Project: IEEE P802.15 Working Group for Wireless Personal Area Networks (WPANs)

Submission Title: Cognitive Spectrum Management (CSM) Signaling Options
Date Submitted: March 6, 2011
Source: Mark Wilbur Company Collaborative Wireless Strategies LLC
Address: Concord Ohio USA
Voice: 01 (440) 221-2101 E-Mail: cws@ieee.org

Cognitive Spectrum Management (CSM) Signaling Options

Comment Resolution

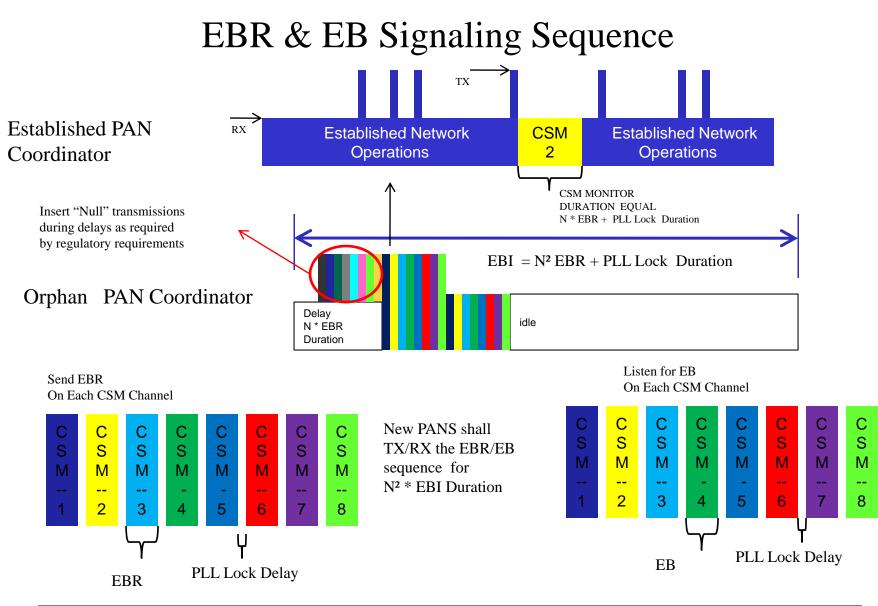
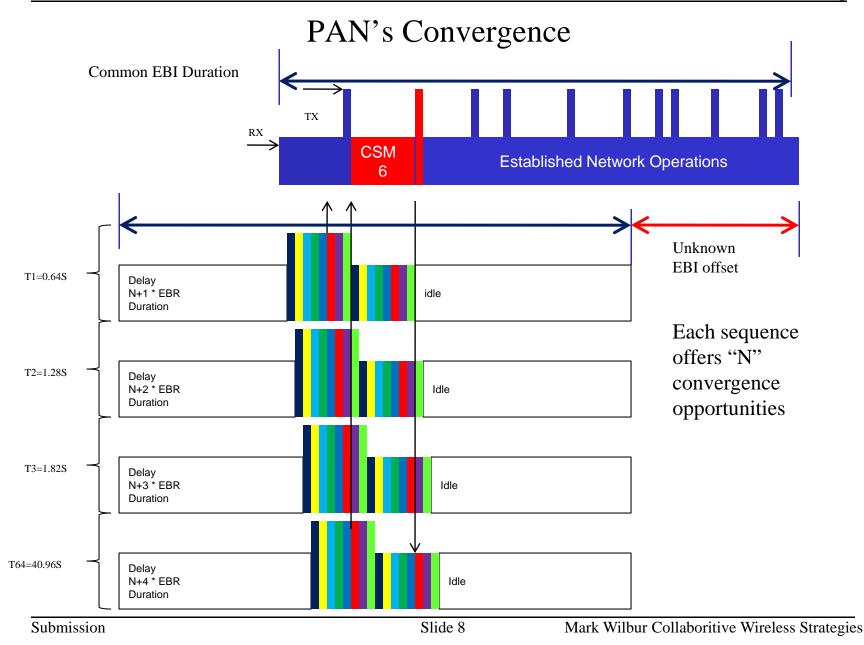
902-928 Band = 128 Valid Channels

"N" = Number of CSM signaling channels = Floor (Valid channels / 16 = 8 (for the 902-928 band)

1/16th of the available channels available in the band selected for coding efficiency (additional research may be required to validate this is the ideal value)

X =1 For N X=X+1

CSM CHANNEL NUMBER = X(floor (((Max Valid Channel -1) – (Min Valid Channel +1) / N))

$CSM \ 01 = 01(floor \ ((128 \ -1) - (1+1) \ / \ 8)) = 015$ $CSM \ 02 = \ 02(floor \ ((128 \ -1) - (1+1) \ / \ 8)) = 030$ $CSM \ 03 = 03(floor \ ((128 \ -1) - (1+1) \ / \ 8)) = 045$ $CSM \ 08 = 08(floor \ ((128 \ -1) - (1+1) \ / \ 8)) = 120$
